Before the
United States Nuclear Regulatory Commission
Docket Nos. STN 50-498, STN 50-499
Houston Lighting & Power Company, et. al.
South Texas Project Units 1 & 2
Amendment 5

Houston Lighting & Power Company, an applicant in the above captioned proceeding, for itself and for the City of San Antonio, Central Power & Light Company and the City of Austin, hereby files Amendment 5 to the Environmental Report - Operating License Stage.

APPENDIX E
SOUTH TEXAS PROJECT
UNITS 1 AND 2

RESPONSES TO NRC
APRIL 28, 1982
REQUEST FOR ADDITIONAL INFORMATION

FIGURE 2.1 - 4

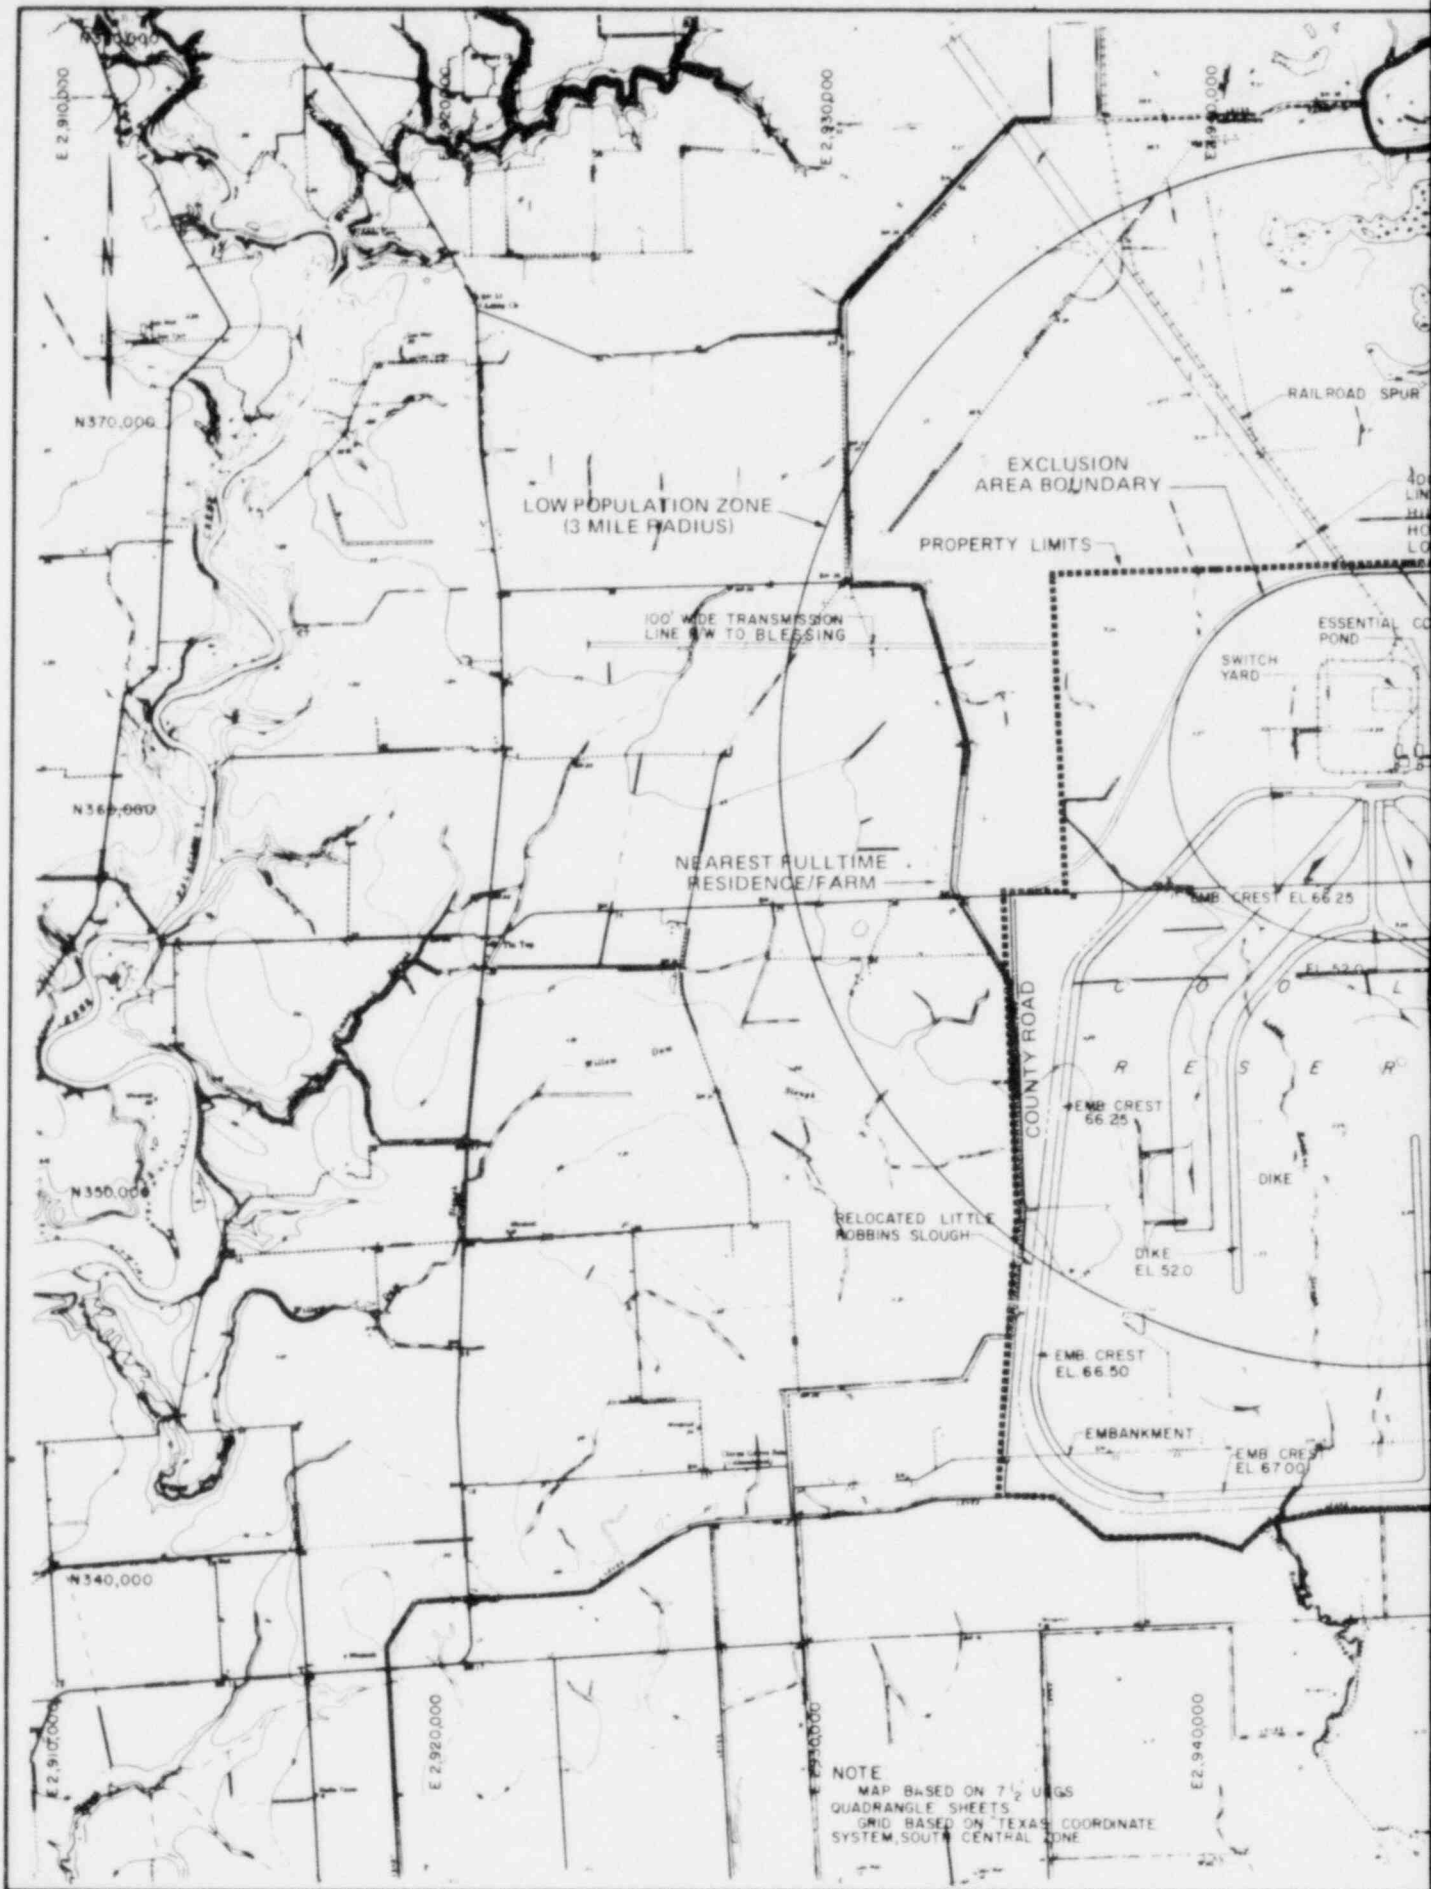
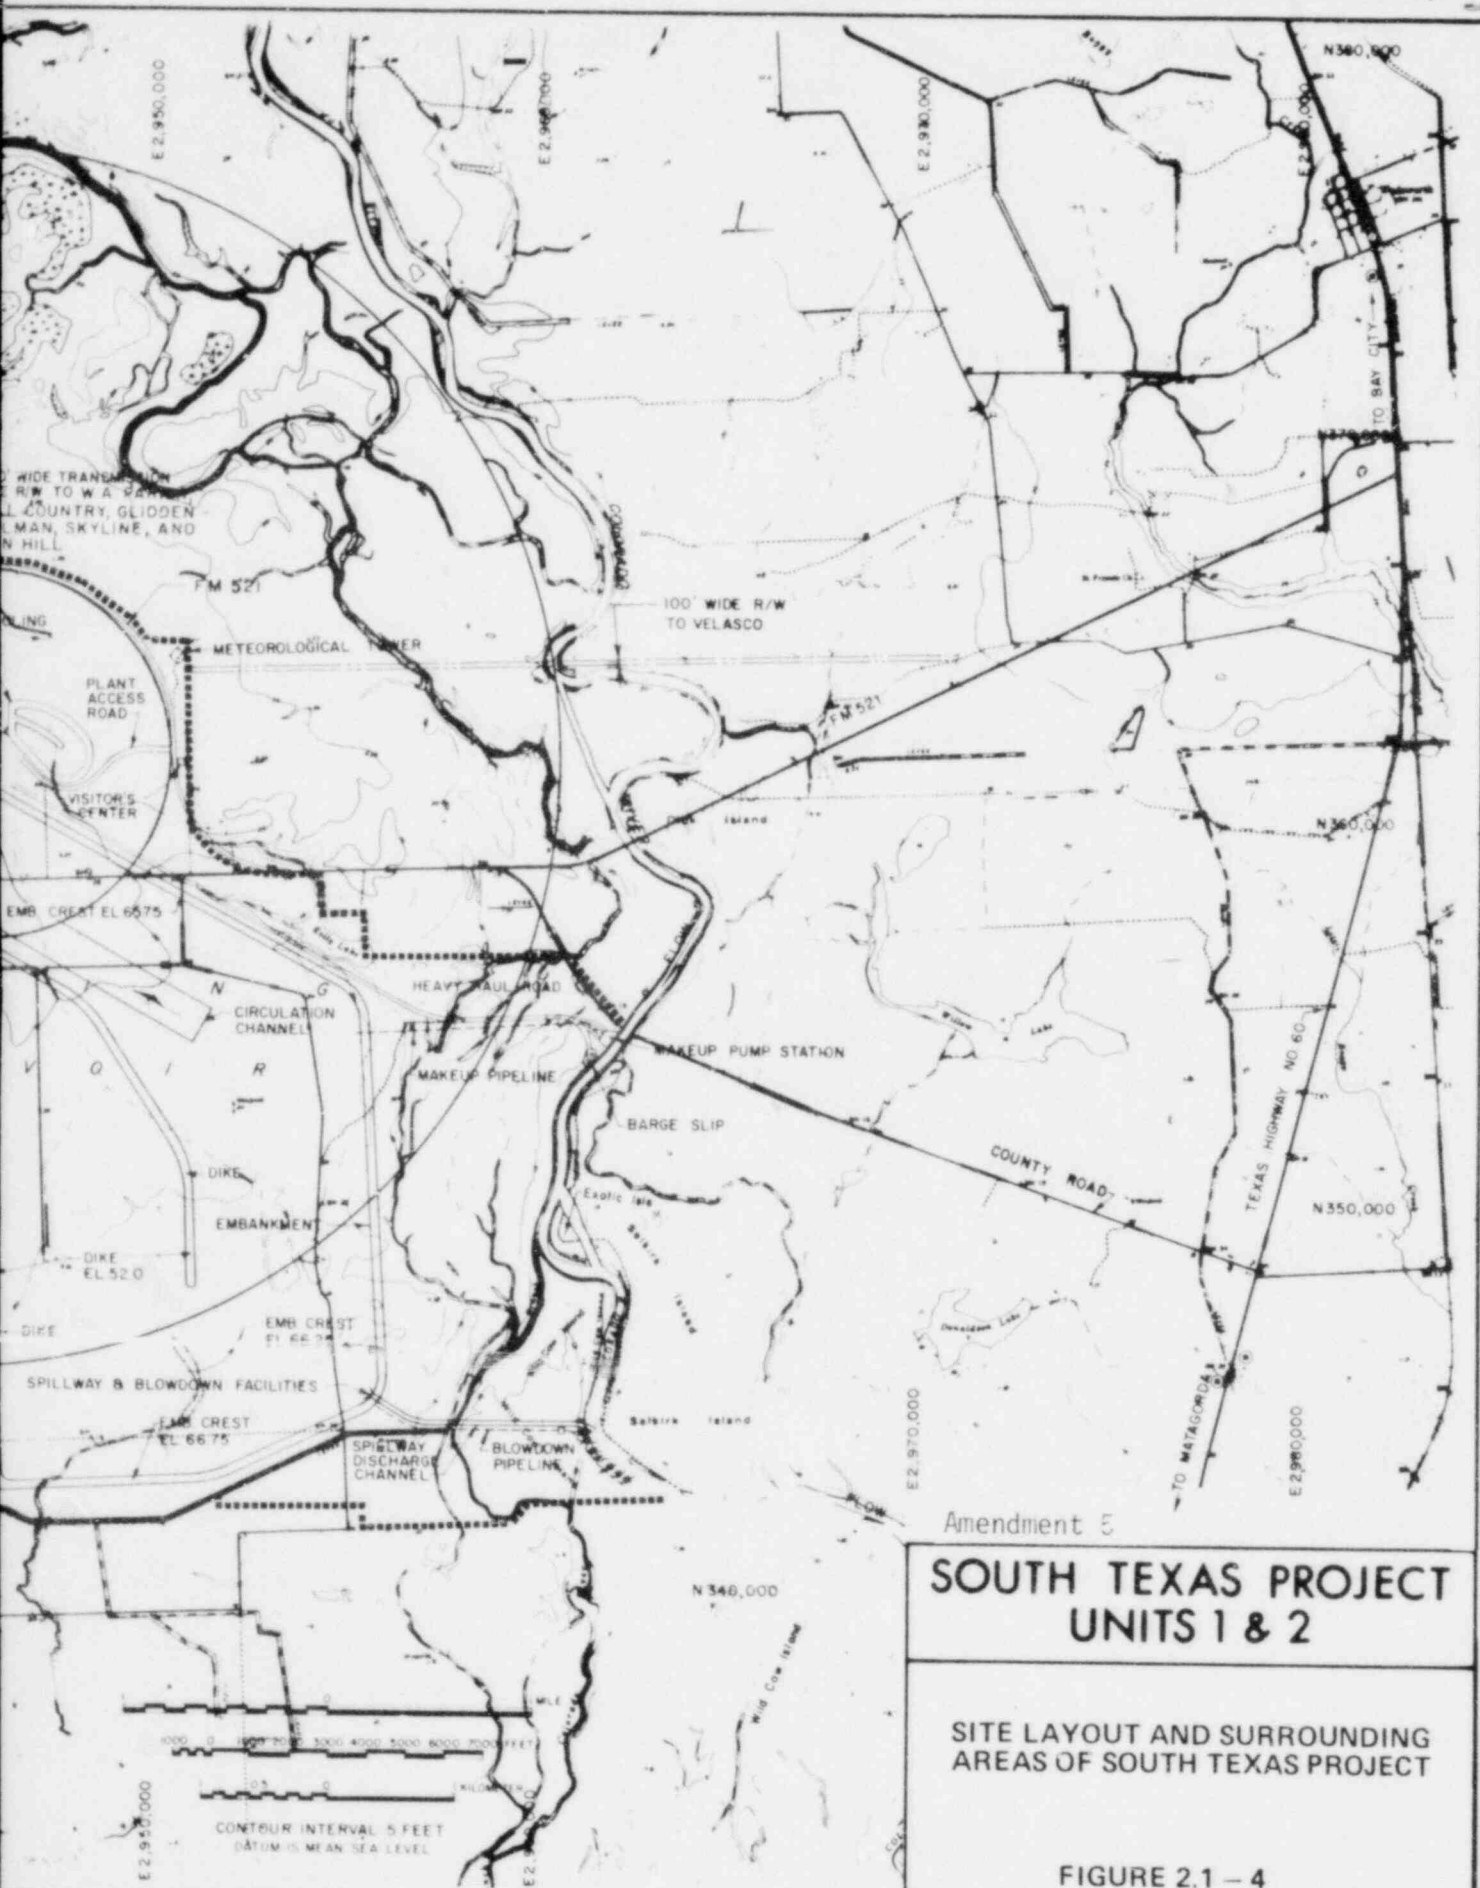
- a) Provide a drawing(s) or a detailed scale map(s) which clearly delineates the exclusion area and low population zone, together or separately, with respect to the reactors and related plant structures within the exclusion area and in relation to the site property and immediate area surrounding the plant. Indicate the scale, orientation, and distances of the various entities.
- b) For clarification, please specify if the 1430 meter minimum exclusion area boundary distance is measured from the center, surface, or midway between the containment buildings.

- a) Requested information is provided on revised Figure 2.1-4.
- b) Requested information is provided in revised Section 2.1.

FIGURE 2.2-1

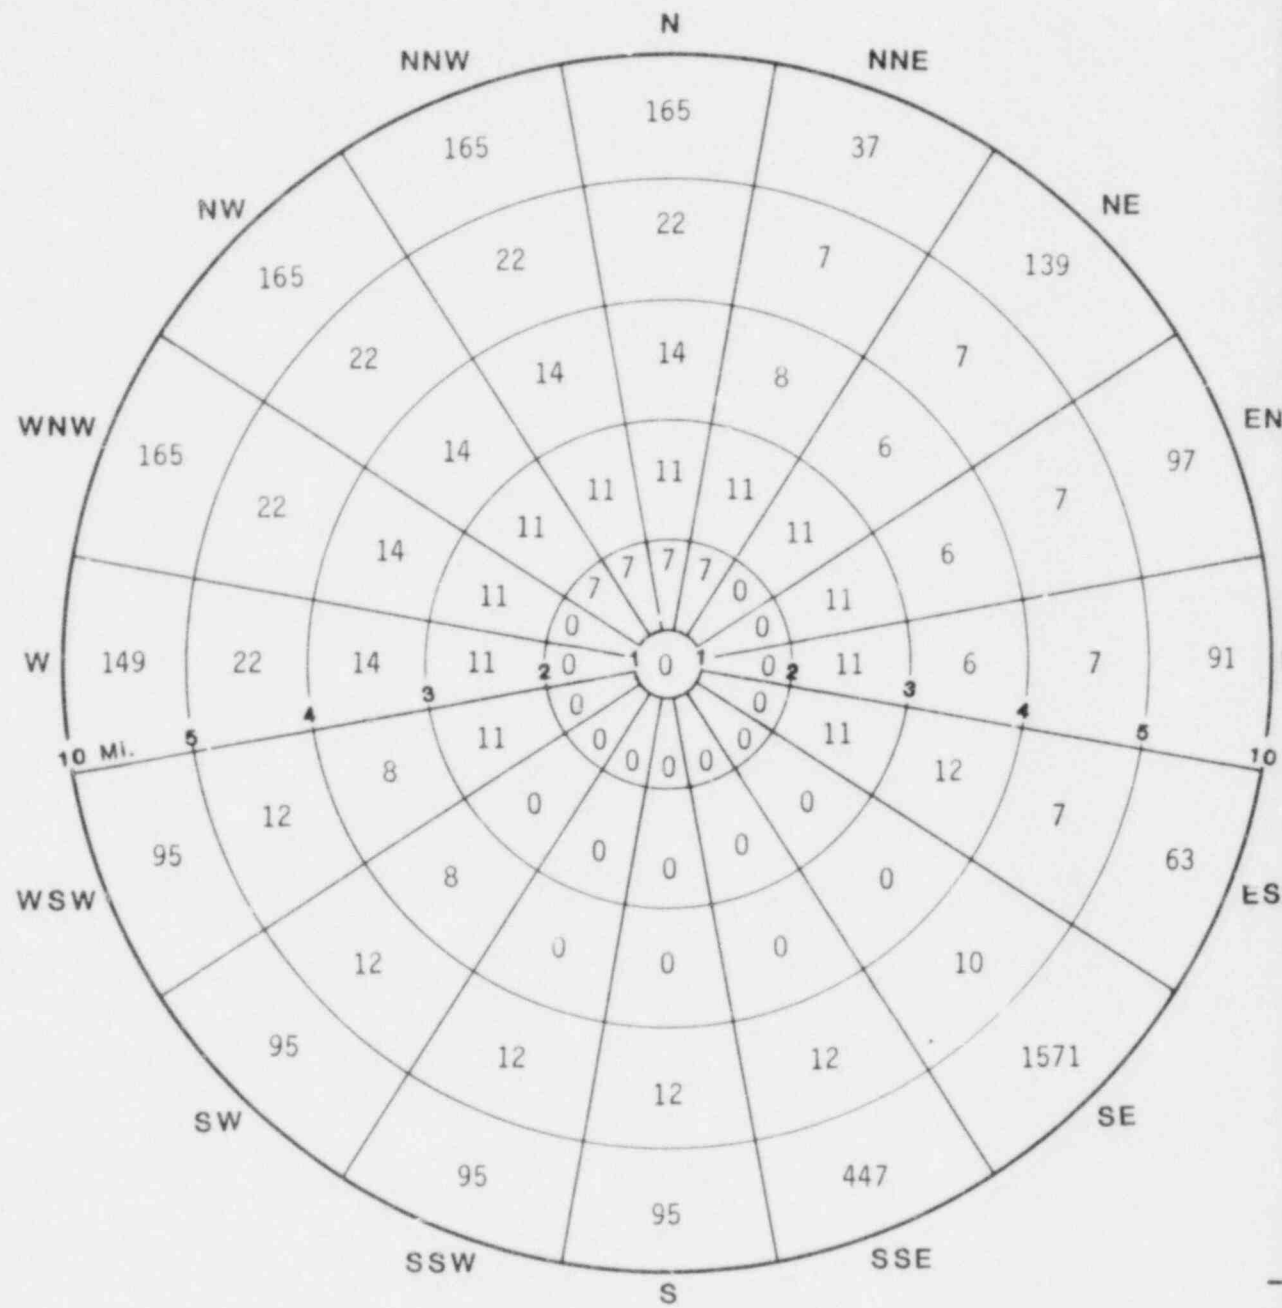
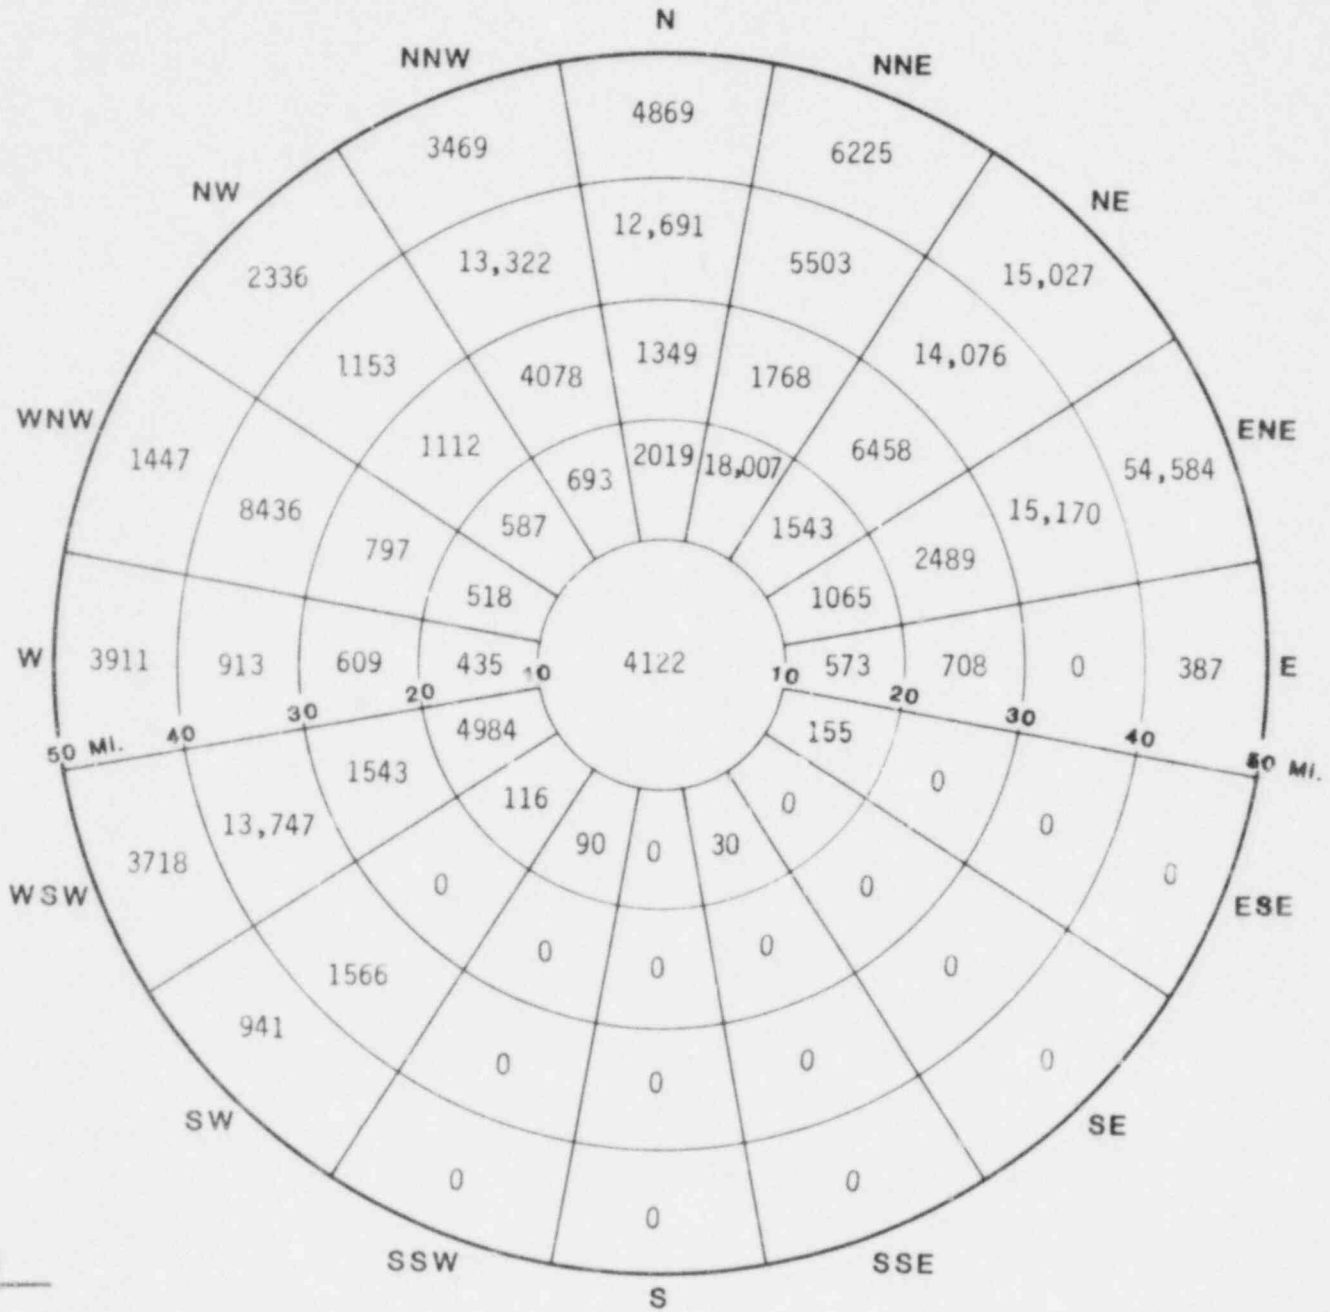
The current population documentation is outdated, and in some instances inconsistent. Please provide an updated Section 2.1.3 which incorporates the 1980 census population data including population projections to the year 2030. Please revise the figures and tables so that they are consistent with the text.

Requested information is provided in revised Section 2.1.3.
